3-J-21-HZ
APPLICATION FOR CERTIFICATE OF APPROPRIATENESS

401 E. Oklahoma Ave. 37917
Old North Knoxville H

Original Print Date: 3/9/2021
 Knoxville/Knox County Planning -- Historic Zoning Commission

Proposed new accessory structure (accessory dwelling unit) to be located behind the primary residence. Overall form and design was reviewed and approved with conditions by the HZC in November 2020. Due to the completion of a survey and site plan constraints; applicant is proposing the rotation of the previously reviewed structure by ninety degrees, with the garage door now facing the alley. Previously approved structure measured 30' wide by 21' deep; new structure to measure 28' wide by 22.5' deep. Structure to be placed to the rear of the primary residence, set 10' from the rear lot line and 5' from the interior side lot line.

Site Plan

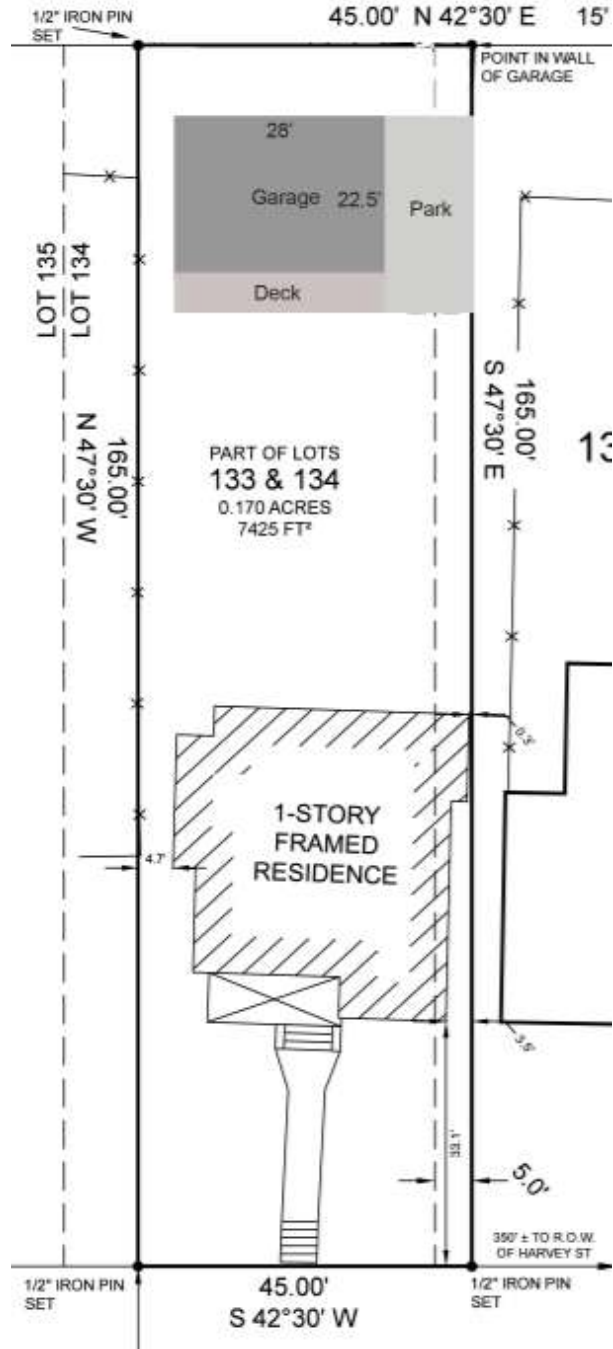
2. The new application proposes rotating the new structure 90 degrees, orienting the garage door towards the alley, and modifying the footprint slightly (from 30' wide by 21' deep to 28' wide by 22.5' deep). The structure will still be located to the rear of the primary residence, 10' from the rear lot line and 5' from the interior side lot line. Per City Zoning ordinance (10.3.P.2.a), when a detached garage is served by an alley, the minimum required setback from the rear lot line is 12' when garage doors are oriented to the alley.

- 1) Revise site plan to show 12' minimum rear setback from the alley;
- 2) Retain previously-approved first-story window sizes;
- 3) Align west elevation door header with windows;
- 4) Install shingles cut specifically to match the main house or use a painted lap siding with a horizontal trim piece separating the first story from upper gable fields.

3d Views: (Before Left, After Right)

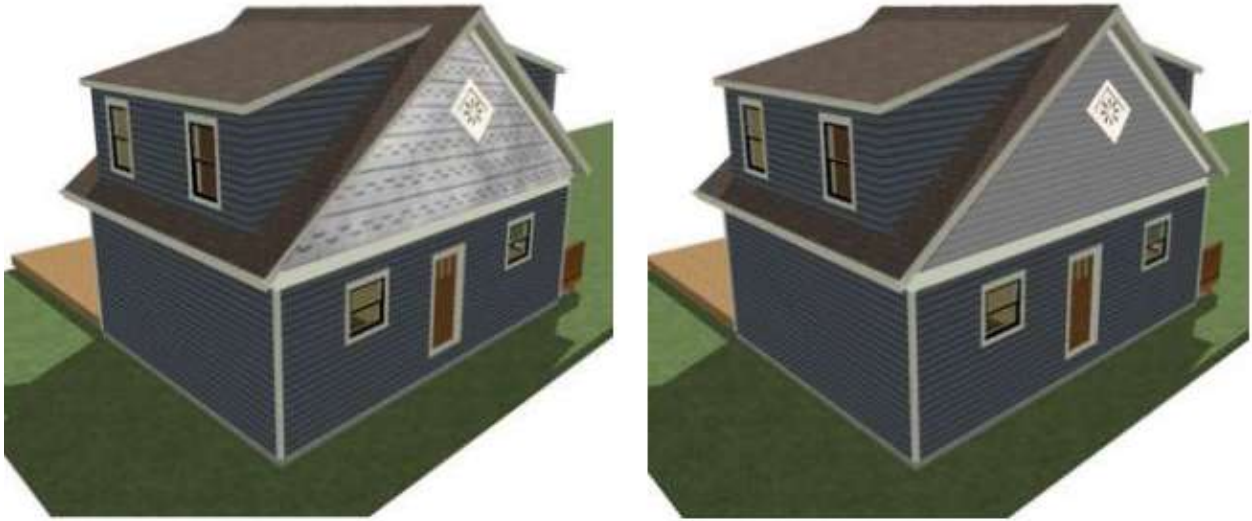
4. Shrinking the first-story windows to 36" by 36" makes them disproportionately smaller than the dormer and gable windows on the second story, and create larger expanses of blank walls. In staff's opinion, the previously-reviewed window sizes should remain in the new design.

5. The west elevation now includes a door on the left side instead of centered on the elevation. The header height of the door should be aligned with the windows' header height.
